# Work Order ID 102007

Item Name: Crosstube Turning Detail

DRAWING NO. D412-664-245	TITLE CROSSTUBE ASS'Y (412 LOW-N AFT)	REV. D	<b>DART AEROSPACE LTD ENGINEERING ORDER</b>		D.E.O. NO. D412-664-245-D-1	SHEET NO. SHEET 1 OF 2	SCALE NTS
DRAWN <i>qp</i>	CHECKED <i>SC</i>	MFG. APPR. <i>R</i>	APPROVED <i>MP</i>		DE APPR. <i>MP</i>		
DATE 11.05.25	DATE 11.05.31	DATE 11.05.31	DATE 11/05/31		DATE 11.05.31

DRAWING NO. D412-664-245	TITLE CROSSTUBE ASS'Y (412 LOW-N AFT)	REV. D	<b>DART AEROSPACE LTD ENGINEERING ORDER</b>		D.E.O. NO. D412-664-245-D-2	SHEET NO. SHEET 1 OF 1	SCALE NTS
DRAWN 92	CHECKED AS	MFG. APPR. E	APPROVED MP		DE APPR. H		
DATE 11.09.07	DATE 11.09.12	DATE 11.09.12	DATE 11.09.12		DATE 11.09.12

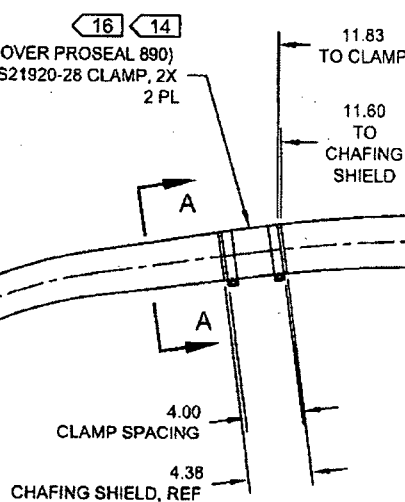
REMOVED ABRASION STRIP IN FAVOR OF A THIN LAYER OF PROSEAL 890. UPDATE INSTALLATION OF CHAFING SHIELDS AND REDUCE TORQUE TO 40-50 IN-LBS. THIS ENGINEERING ORDER SUPERCEDES DEO D412-664-245-D-1

NOTE 14 AND 16 ON SHEET 1 IS AMENDED AS FOLLOWS:

- 14) APPLY A THIN COAT OF PROSEAL 890 ON INSIDE CONCAVE SURFACE OF D3189-1 CHAFING SHIELD AND LET CURE PER MANUFACTURER'S INSTRUCTIONS. INSTALL PROSEALED D3189-1 CHAFING SHIELD ONTO CROSSTUBE BY APPLYING A THIN COAT OF PROSEAL 890 ONTO CROSSTUBE. BE SURE TO ELIMINATE ANY AIR GAPS.
- 16) TORQUE CLAMPS ON D2896-1 SUPPORT 80 TO 100 IN-LB. **TORQUE CLAMPS ON D3189-1 CHAFING SHIELD 40 TO 50 IN-LB.** ENSURE AT LEAST 1.5 THREADS SHOWING IN SAFETY AND THAT NUT HAS NOT BOTTOMED-OUT AFTER TORQUING.

**SECTION A-A**  
CHAFING SHIELD DETAIL  
VIEW ROTATED, NOT TO SCALE

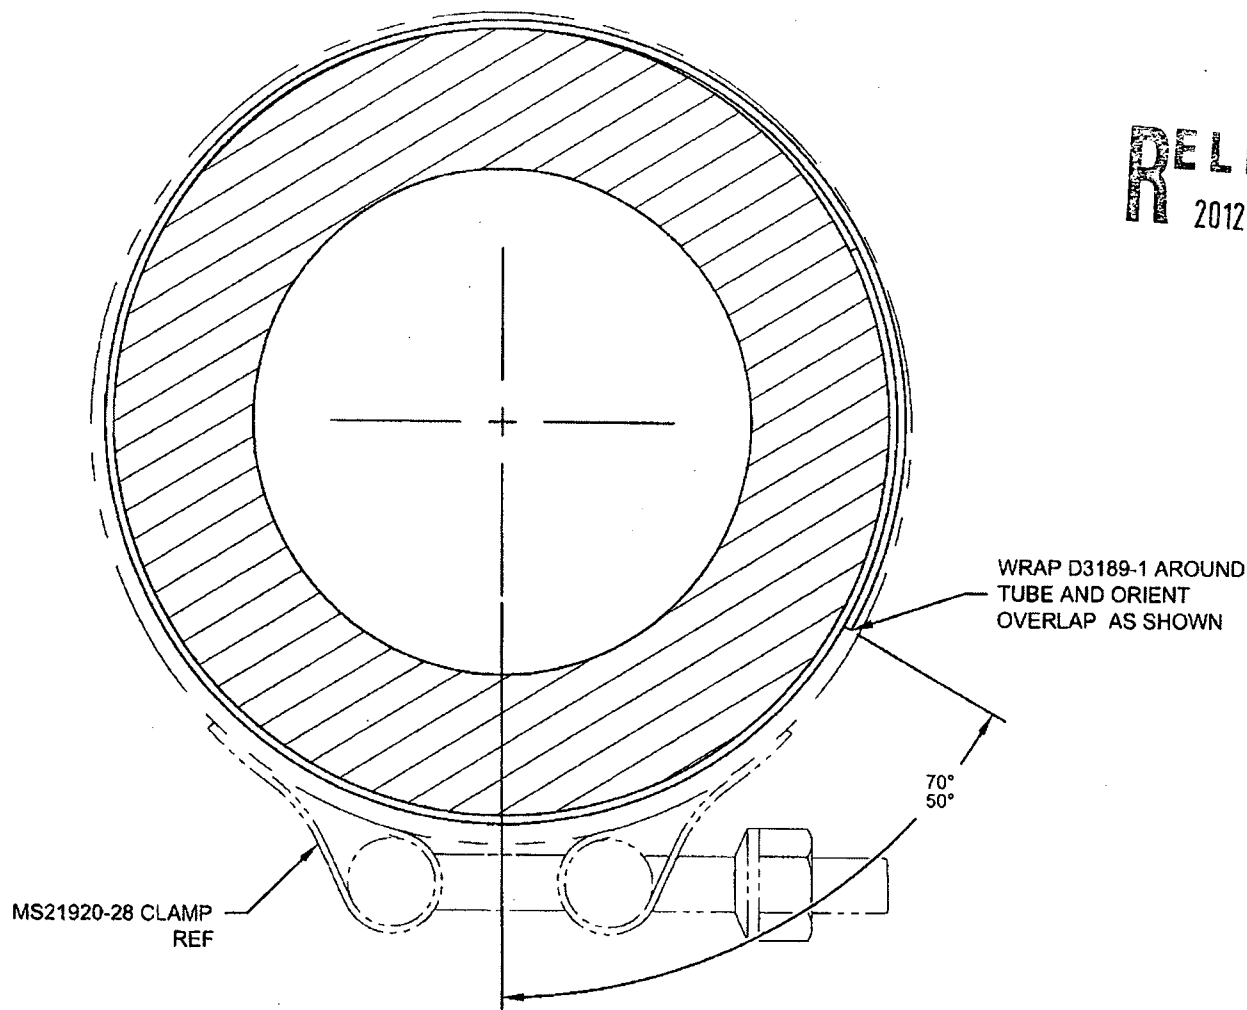
DRAWING NO. D412-664-245	TITLE CROSSTUBE ASS'Y (412 LOW-N AFT)	REV. D	DART AEROSPACE LTD ENGINEERING ORDER	D.E.O. NO. D412-664-245-D-3	SHEET NO. SHEET 3 OF 3	SCALE NTS
DRAWN 97	CHECKED	MFG. APPR.	APPROVED	DE APPR.		
DATE 12.08.21	DATE 12.08.27	DATE 12.08.29	DATE 12.08.29	DATE 12.08.29
